## **STAFF MEMO**

**Date:** March 1, 2021  
**To:** Town of Milford Planning Board  
**From:** Jason Cleghorn, Town Planner  
**Subject:** **SP2021-07 and SD2021-05 B33 Lordens Plaza (applicants/owners), 586 Nashua St., Map 44, Lot 6.** Public Hearing for the review of a major site plan related to the construction of a proposed 2,250 s.f. coffee shop with drive thru lane and a minor subdivision to create a 30,912 s.f. lot from the overall Lordens Plaza for the purposes of the construction on this pad site within the Commercial “C” zoning district.

Site Plan Sheet showing the access drive aisle, the proposed building and the queuing for ten vehicles

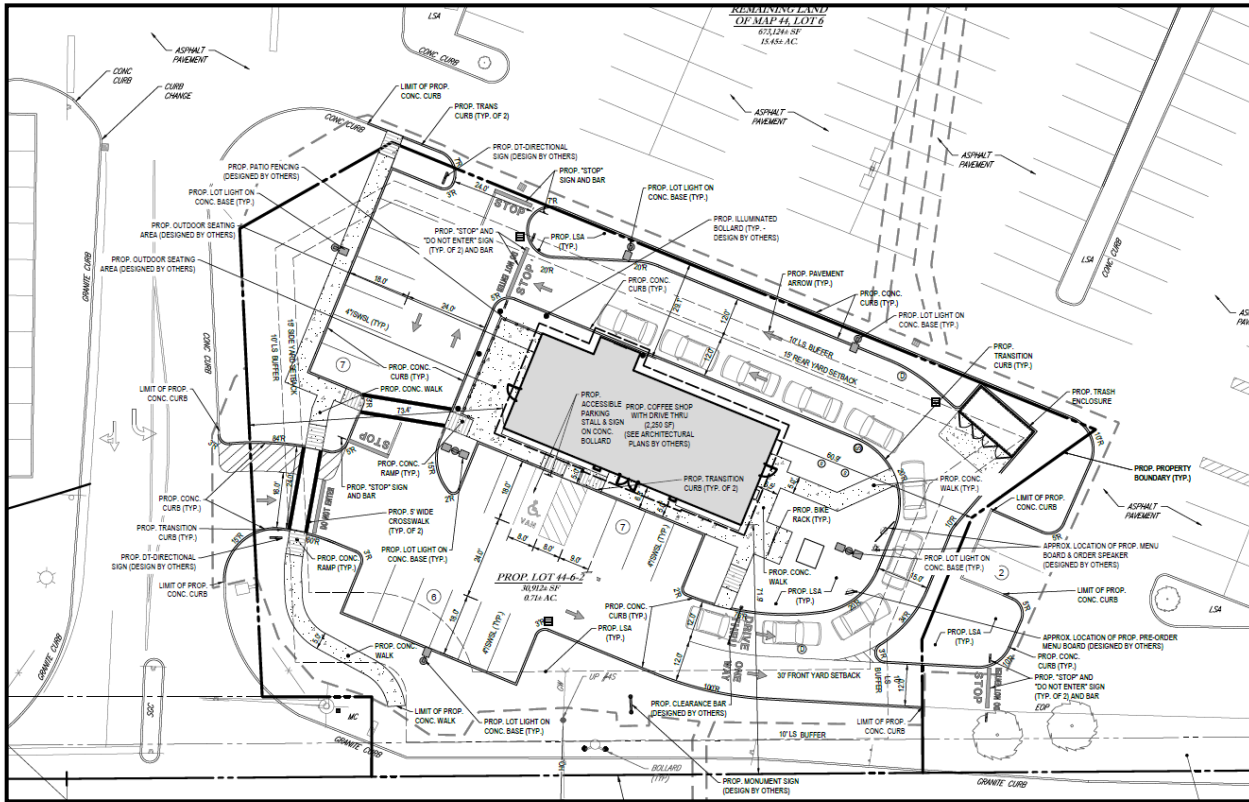
Staff has some concern with the limited number of queuing space for vehicle storage onsite being limited to ten (10) vehicles. Observations elsewhere with comparable properties and uses have shown queuing far in excess of these amounts.

Additionally, staff is concerned about the limited space for the turning movement off of the access drive aisle and its short distance away from Nashua Street.

4. SITE PLAN: Table 1 of the *Traffic Impact Assessment* omits the Saturday midday peak-month volumes referred to in subscript letter d.
5. SITE PLAN: Staff remains concerned about the relative lack of queuing space (ten (10) vehicles). Analysis provided by a traffic engineer on the town's zoning board of administration shows that based on *Kendall's Notation on the Mathematical Theory of Probability* and *Andrey Markov's Queue Theory*, up to eighteen (18) vehicles may be

queuing at the 95<sup>th</sup> percentile. Given the short distances involved between the site's entrance off of the entrance drive aisle and Nashua St., this is problematic. Staff has observed other locations in the general area with many more than ten (10) vehicles queuing.

SHEET TITLE: **SITE LAYOUT PLAN**  
 SHEET NUMBER: **C-302**  
 ORG. DATE - 02/11/2021

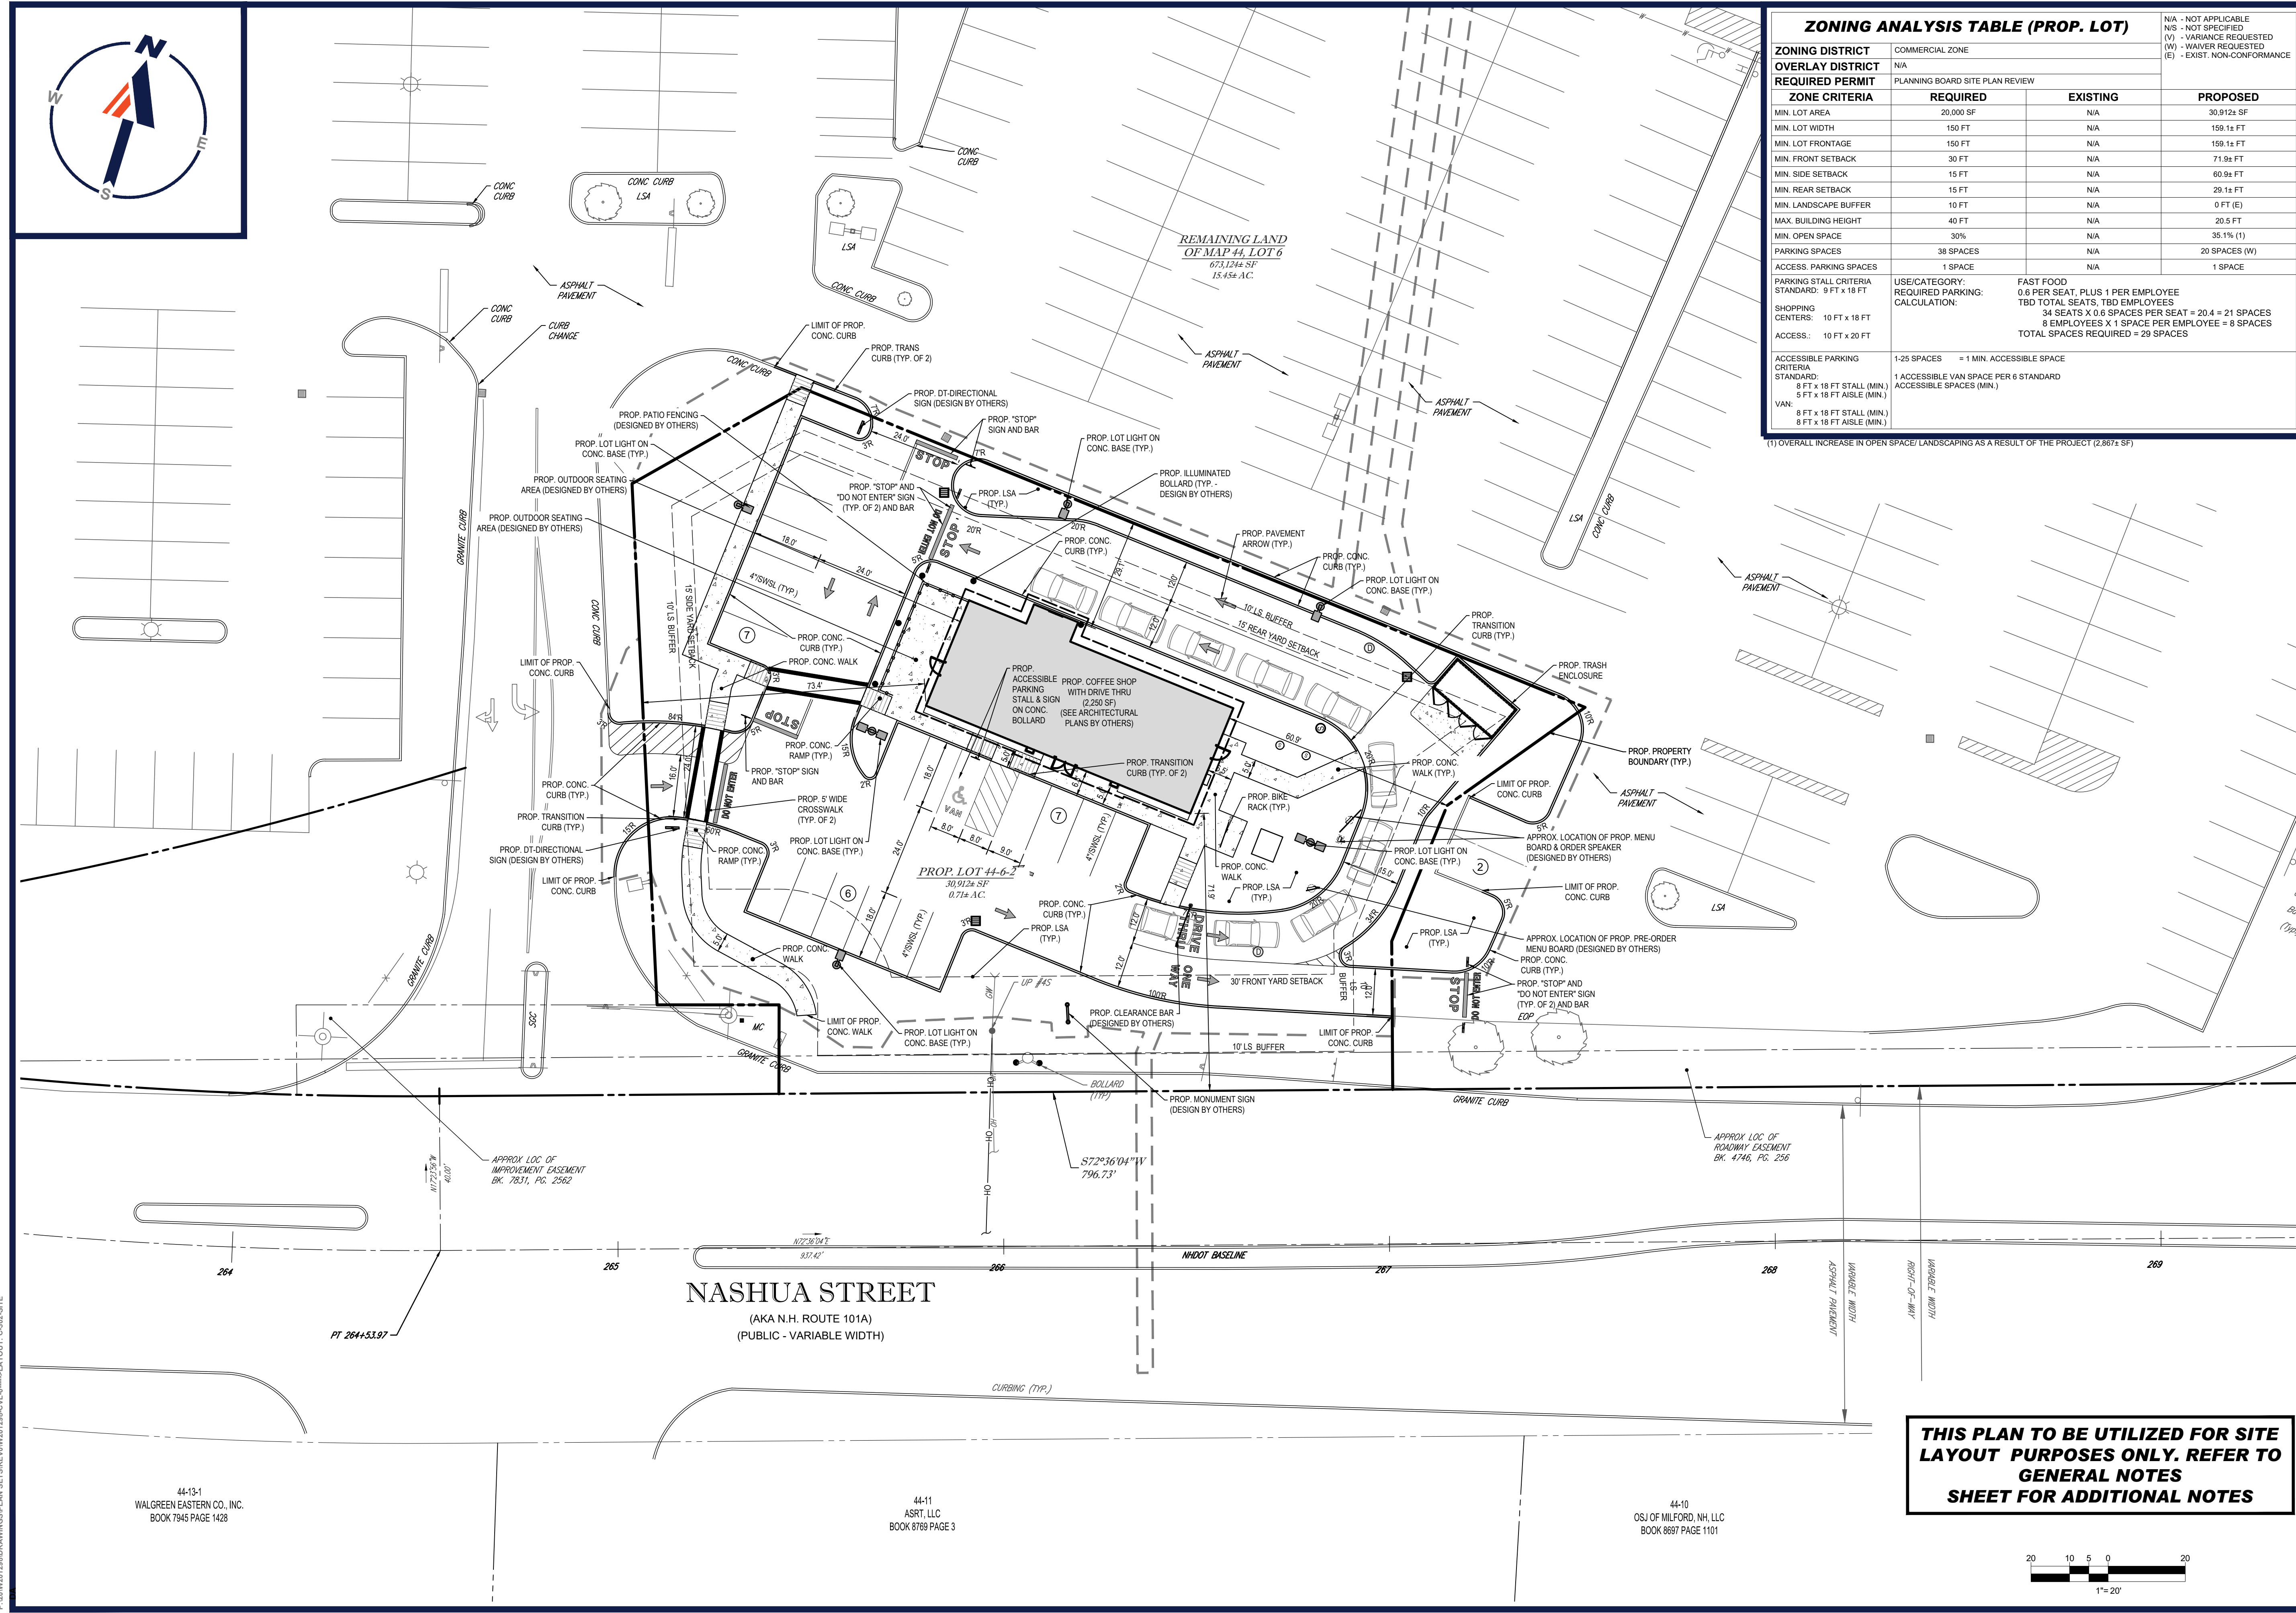
2. SITE PLAN: Change all references as it pertains to this project from Proposed Lot 6-1 to Proposed Lot 6-2 throughout.
3. SITE PLAN: There was discussion at the Planning Board's conceptual review about pedestrian connections to the north (the parking area as part of the Lordens Plaza). Staff supports this connection and the plan should be revised to extend the sidewalk at the side of the building or at a minimum, provide striping designating a pedestrian path as was discussed at the aforementioned conceptual hearing.
